Access Compliance Report

Public Rights-of-Way (Curb Ramps)

Intersection ID: 7900	Main Street: EDGERTON_DR	Cross Street: SNOW_WHITE_LN	Location: SW
ADA ID: 23D7B7E76629	Ramp Type: Directional1	Initial Pass/Fail: Fail	Overall Compliance: No
Severity Score: 12.5			
Codes/Mitigation Info/Possible Solution		Field Measurements/Component Compliance

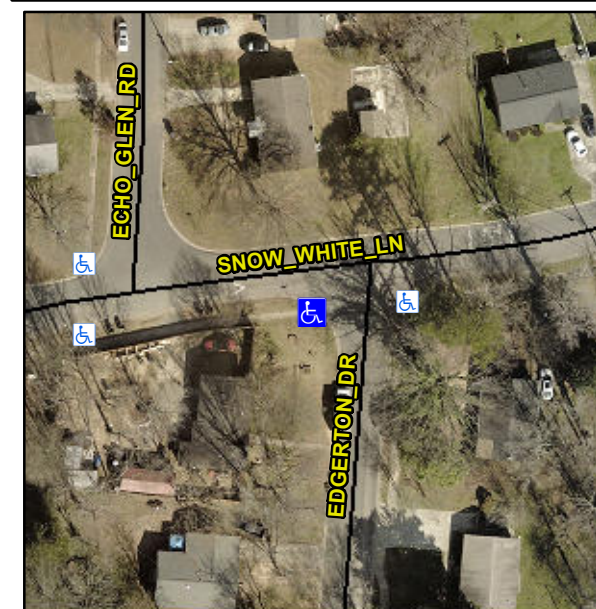
Compliance	Description	Data	Compliance	Description	Data
N/A	Ramp Length (in)	25.0	N/A	Grade Break?	N/A
Yes	Ramp Width (in)	51.0	N/A	Grade Break Slope (%)	0.0
No	Ramp Slope (%)	9.8	N/A	Grade Break XSlope (%)	0.0
Yes	Ramp XSlope (%)	1.1			
N/A	Flare Type LT	N/A	N/A	Flare Type RT	N/A
N/A	Flare Slope LT (%)	N/A	N/A	Flare Slope RT (%)	0.0
N/A	Flare Traversable LT?	N/A	N/A	Flare Traversable RT?	N/A
N/A	Landing Length (in)	0.0	N/A	DWS Provided?	N/A
N/A	Landing Width (in)	0.0	N/A	DWS Contrast?	N/A
N/A	Landing Slope (%)	0.0	N/A	DWS Length (in)	N/A
N/A	Landing X Slope (%)	0.0	N/A	DWS Full Width?	N/A
N/A	Landing Curb? (Y/N)	N/A	N/A	DWS Offset LT (in)	N/A
N/A	Shared Landing?	N/A	N/A	DWS Offset RT (in)	N/A
N/A	Gutter Ponding?	0.0	N/A	Gutter Slope (%)	N/A
N/A	Gutter Lip Ht (in)	0.0	N/A	Gutter X Slope (%)	N/A
N/A	Painted X Walk1?	No		Road Slope (%)	0.7
	X Walk 1 Direction	To E		Road X Slope (%)	4.1
	X Walk 1 Width (in)	N/A		Clear Space?	N/A

X Walk 1 Slope (%)	0.7	N/A	Clear Space to XWalk (in)	N/A
	X Walk 1 X Slope (%)	4.1	N/A	Storm Grate/Utility Hazard?	N/A
N/A	Ramp inside XWalk1?	N/A		Storm Grate/Utility Type	
N/A	Any Obstructions?	N/A			N/A
	Obstruction Type		Yes	Surface Condition? (G/P)	Good
			N/A	Curb Slope (%)	16.5

Remove & Replace Entire Ramp.

R304.2.2
